August 31, 2016

Re: NIRB File No. 11EN010 Application No: 124668 – Opportunity to address comments received regarding Agnico Eagle Mines Ltd.’s “Amaruq Exploration – Portal/ Ramp, Quarry and Advanced Underground Exploration and Bulk Sample” project proposal

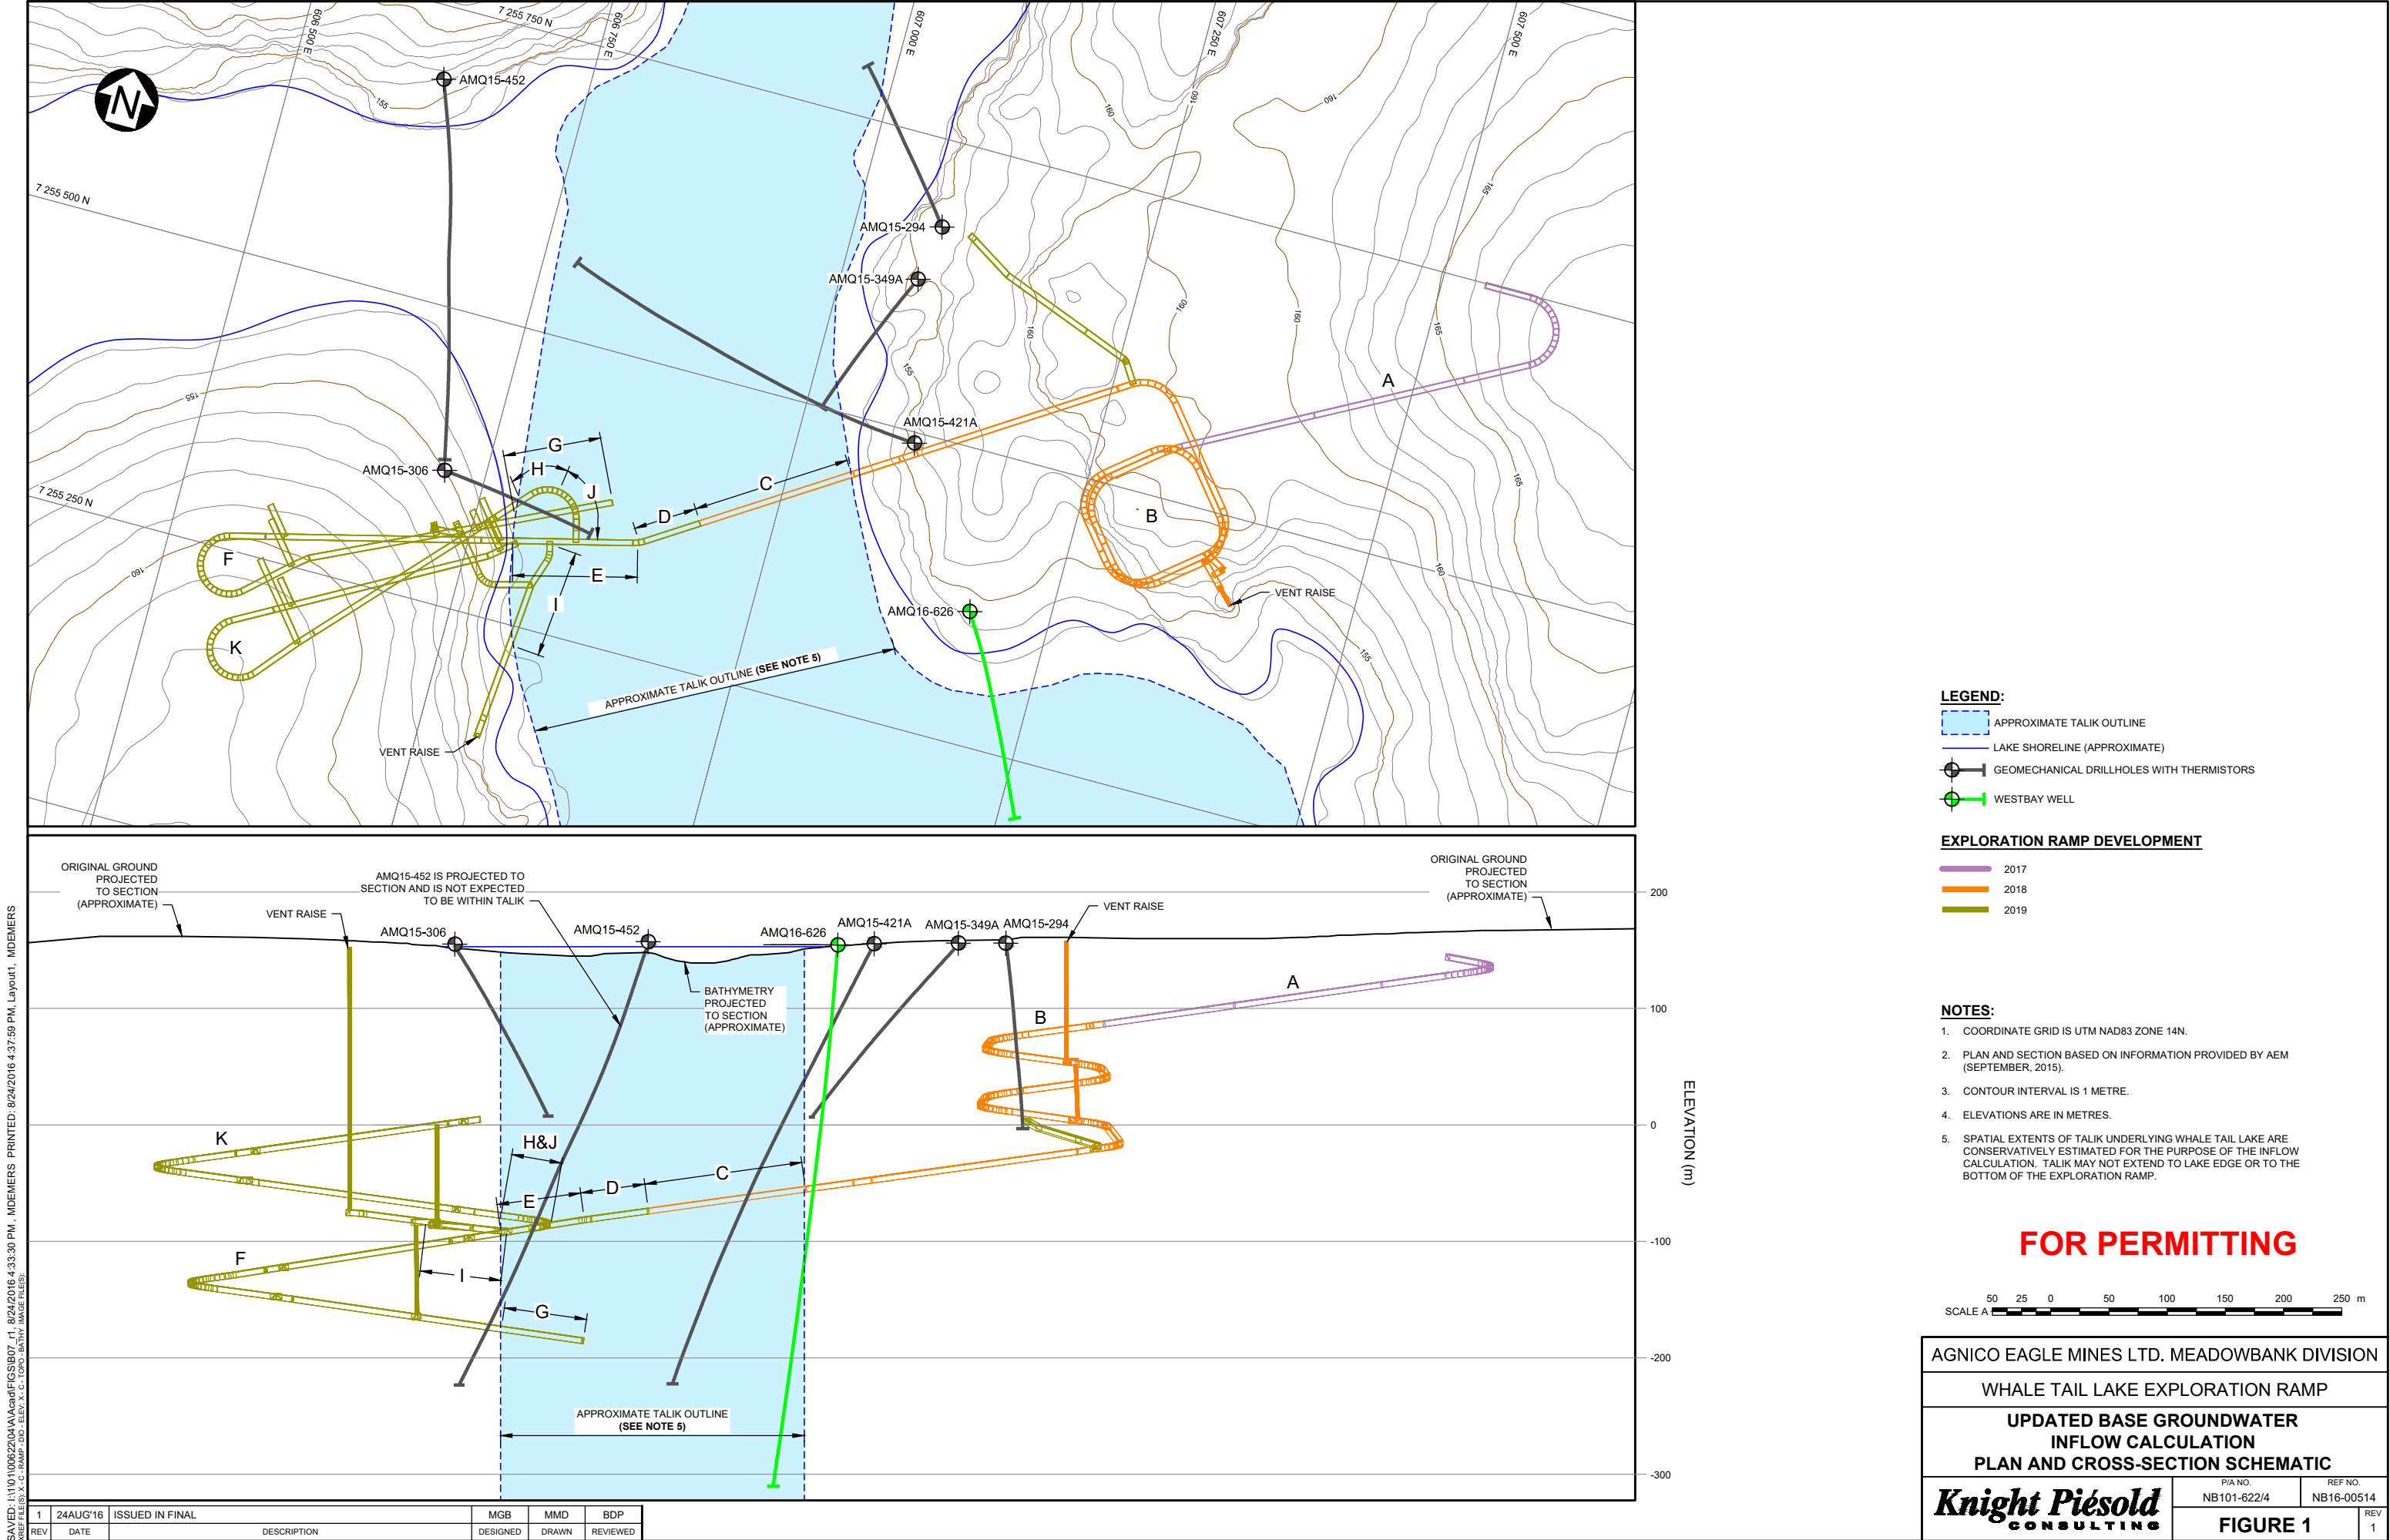
- 3.4 Lack of information on the groundwater and the potential groundwater inflows into the underground workings as follows:
- i) The depth of the underground workings area as they cross the Whale Tail Lake talik;
 - ii) Shape of the talik under Whale Tail Lake;
 - iii) Location of any vent raise;
 - iv) Projected water flow rates;
 - v) Details on how much of the Meadowbank data which is used as the template for the Amaruq Gold Project, is real and how much is a projection to the depths of the proposed Amaruq underground workings in determining the total dissolved solids projection;
 - vi) Potential saline content of any groundwater encountered; and
 - vii) Depth of Whale Tail Lake versus the depth of the underground workings.

In response to the above comments, please refer to an updated Figure 1: Base Groundwater Inflow Calculation Plan and Cross Section, for questions about the depth of the underground workings, shape of the talik, location of the ventilation raises and engineered ramp. The underground workings cross the talik at a depth of approximately 250m below the surface. The underground workings are approximately 210 m below the bottom of Whale Tail Lake.

Update to Golder (2016) - Figure 2: Carbonate Neutralizing Potential vs Acid Potential – Ramp and Portal Samples

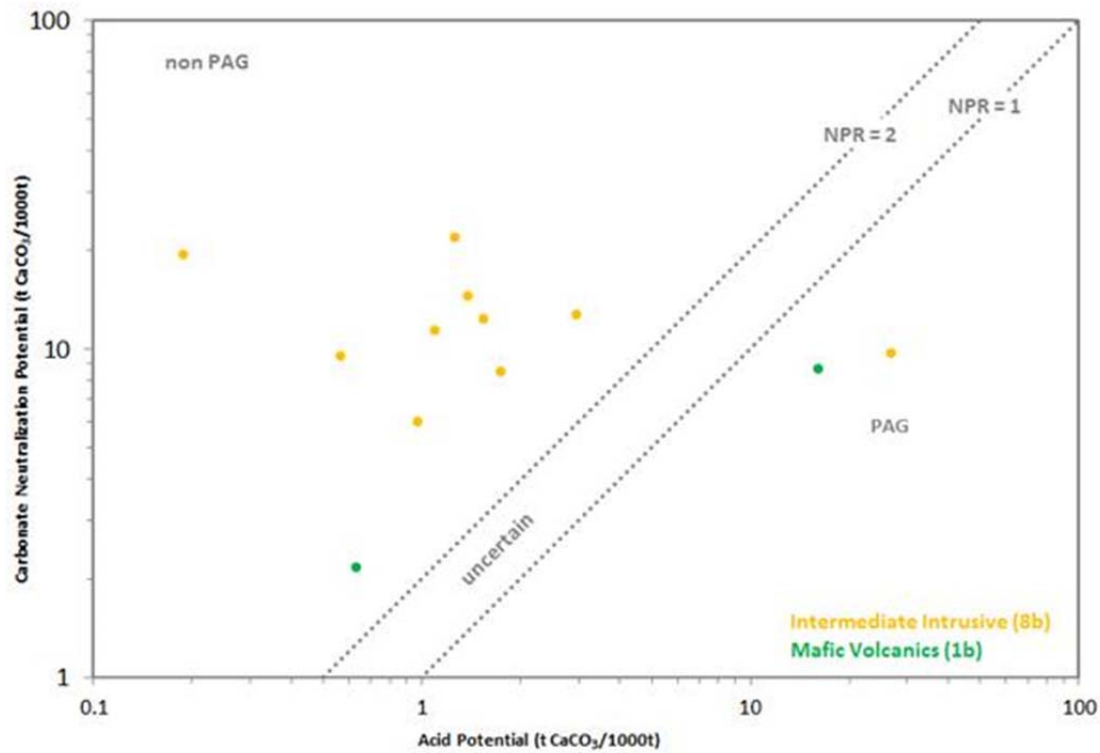
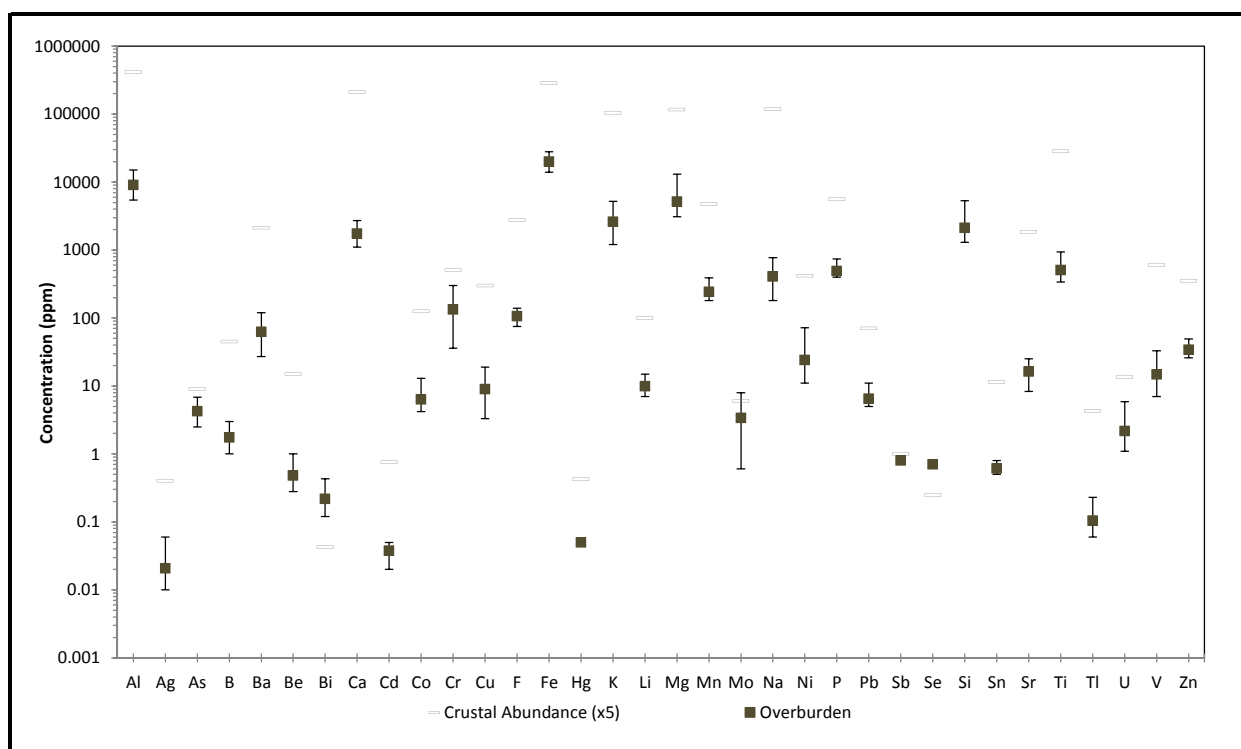
4.4 The analyses of the rocks closer to the deposit within the development of the ramp should not be limited to arsenic, but include other metals of concern. Further, the geochemical database for PAG and non-PAG rock should be expanded for several elements to better determine the extent and significance of leachable metals within all rock types.

Agnico Eagle appreciates the feedback from ECCC and KIA and below has updated Figure 2, page 7 of Golder (2016) Evaluation of Geochemical Properties of Waste Rock from the Underground Ramp, Whale Tail Underground Deposit, Amaruq Project. Agnico Eagle agrees with the comments and will continue to expand the geochemical database of kinetic and static testing to better determine the extent and significance of leachable metals within representative rock types. It is important to note that the ramp is deliberately designed to be within geotechnically stable, NPAG, non-metal leaching material (Intermediate Intrusive and Mafic Volcanic). Only a small proportion of the underground development will generate ultramafic and iron formation waste rock, which have the highest risk for arsenic leaching but also have a low potential for acid generation. Furthermore, the number of samples collected specifically targeted areas within area of the ramp to meet standard statistical approach for the

The sampling plan also considered the much larger dataset obtained from the characterization of waste rock from the open pit. As demonstrated in Figure 6 on page 12 of Golder (2016), there is a clear distinction between lithologies that provides confidence in our ability to predict NPAG vs PAG. The dataset for greywacke from the underground development shows two distinct populations of samples: samples that have a high sulphur content and low buffering capacity which are PAG and samples that have noticeably higher carbonate buffering capacity and very low Sulphur content which are NPAG. This pattern is also observed in the larger geochemical database for the deposit where greywacke has higher sulphur content in close proximity to the ore zone whereas greywacke located at a further distance from the ore zone is generally non-PAG and with low sulphur content. A sulfur content cutoff of 0.2% is proposed to distinguish between PAG and NPAG rock which may be overly conservative for greywacke in the underground development where a lower value of 0.04% could potentially be considered. Accordingly, the greywacke lithology is considered to have a variable ARD potential depending on the location of the material with respect to the ore zone. This makes greywacke suitable for segregation during mining. These characteristics are consistent within each lithology whether samples are from the ramp, the underground development or the open pit areas.

Appendix A – Summary of Amaruq Overburden Geochemical Results

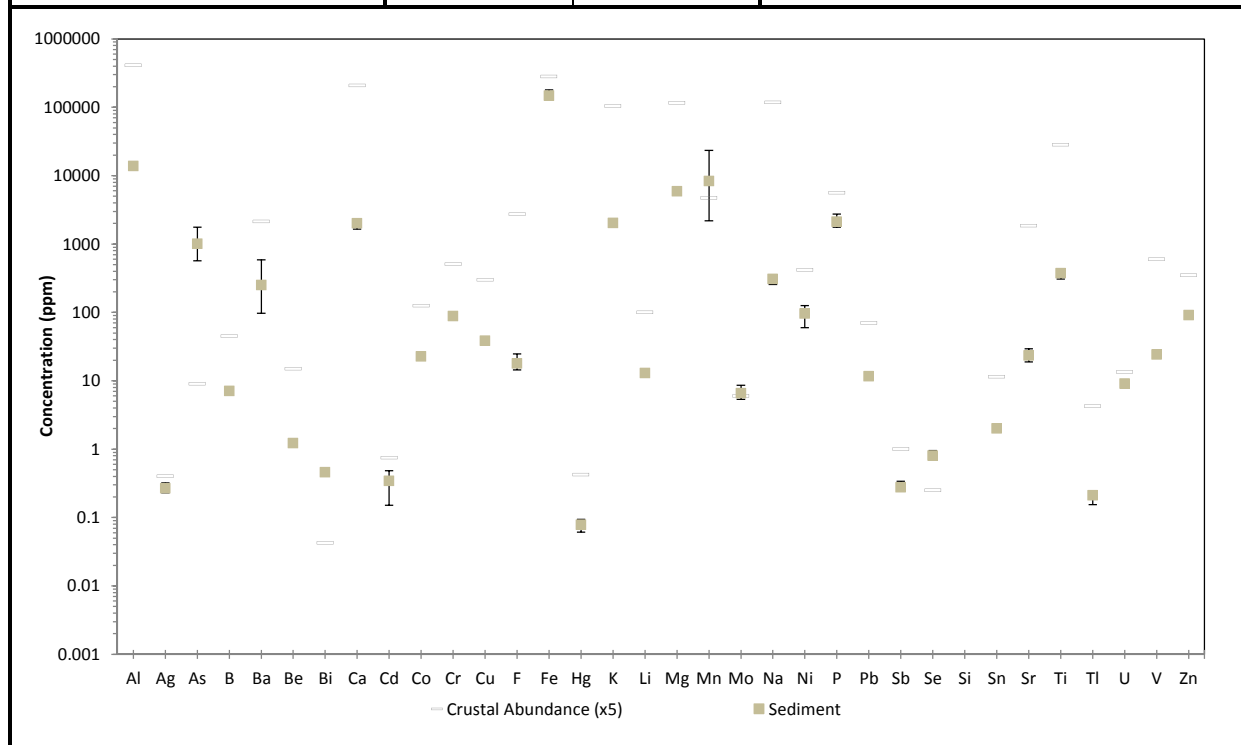
- i) Volumes for the rock quarry, services pad and operations pad,
- ii) Tonnage and rock volumes to be removed, and
- iii) Testing of the overburden material that would be used in pad construction.

Attached in Appendix A you will find a summary of the overburden geochemistry results from samples taken near the Amaruq Exploration Quarry and Portal/ Ramp in 2015. In total 12 samples were collected and analyzed in 2015. Additional samples of the overburden will be collected in 2016 in preparation of ramp development.

- i) Rock quarry volume – approximately 360,000 m³
Service pad volume – maximum 63,432 m³
Operations pad volume – maximum 85,012 m³
- ii) Tonnage and rock volume removed – 258,619 m³
- iii) Testing of overburden material is provided in Appendix A. Additional testing will be undertaken in 2016.
